ENGINEERING SERVICES REPORT

NORTH HARBOUR PRECINCT 1

Prepared for **North Harbour Holdings Pty Ltd**

DRAWING TITLE		
TURN MANOEUVRE LAYOUT PLAN SHEET 1 OF 2		
PROJECT No.	DRAWING No.	REVISION
23-000077.03	080

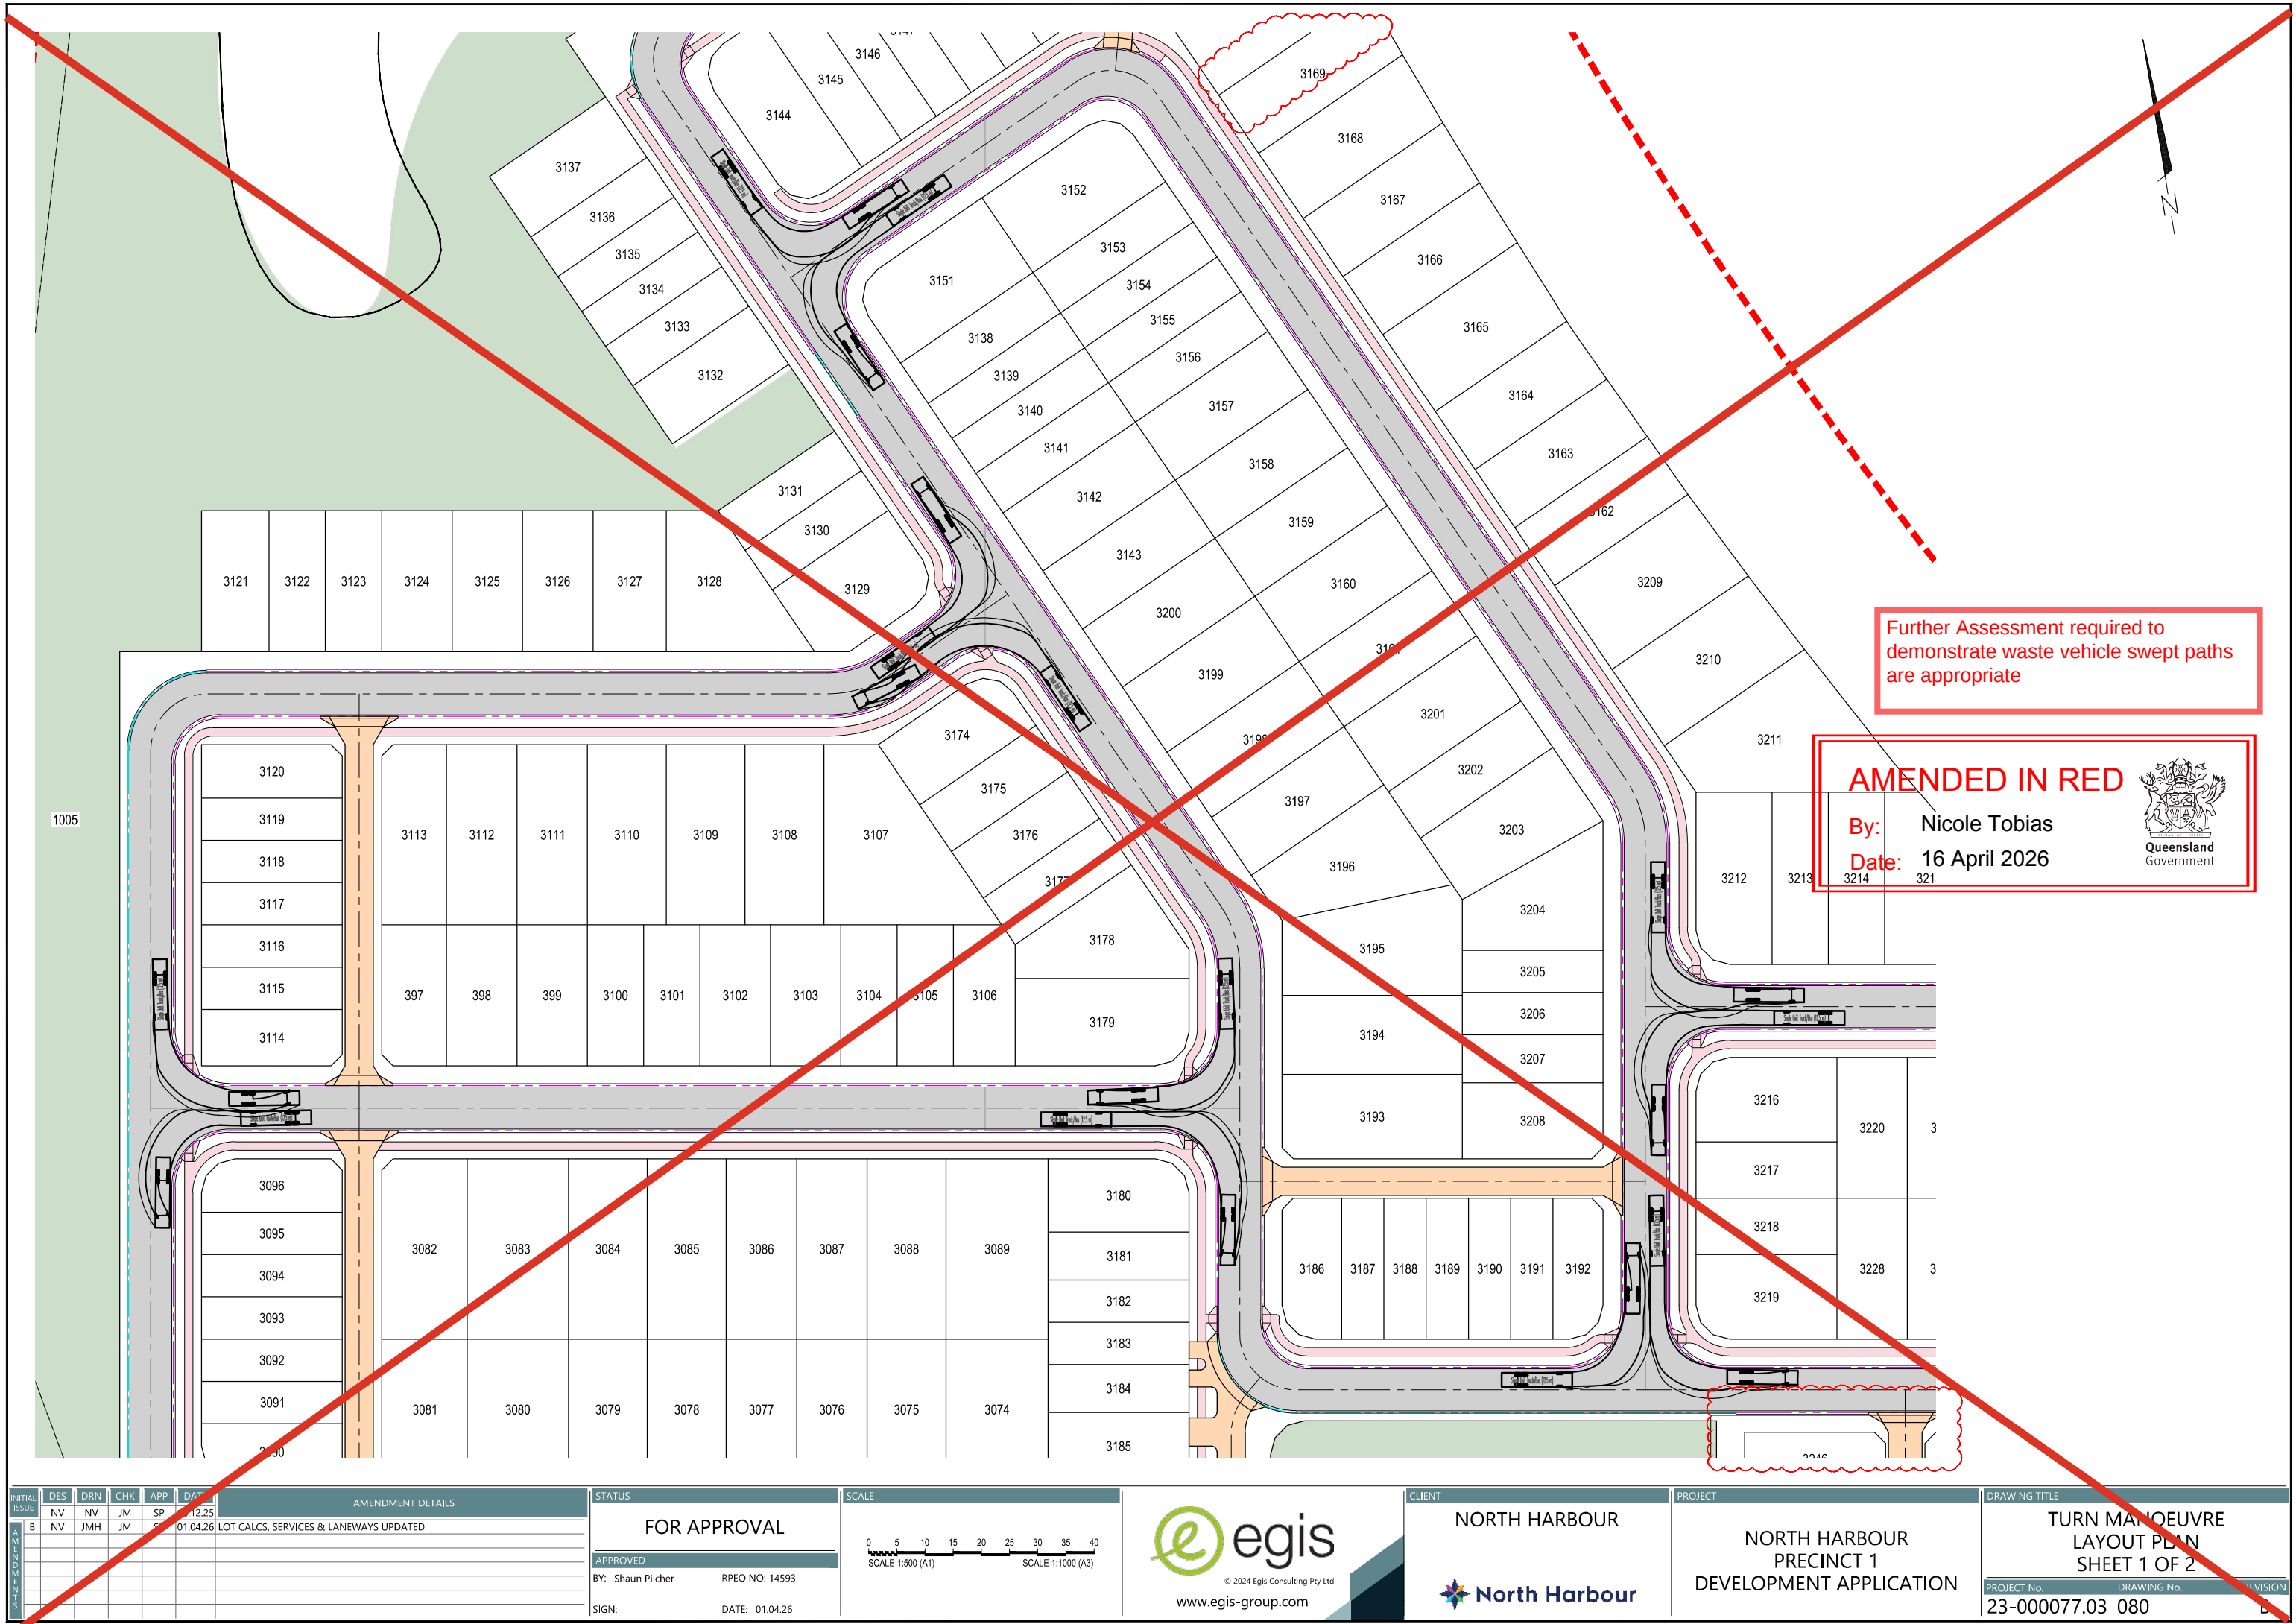
Further Assessment required to demonstrate waste vehicle swept paths are appropriate

~~AMENDED IN RED~~

By: Nicole Tobias
Date: 16 April 2026
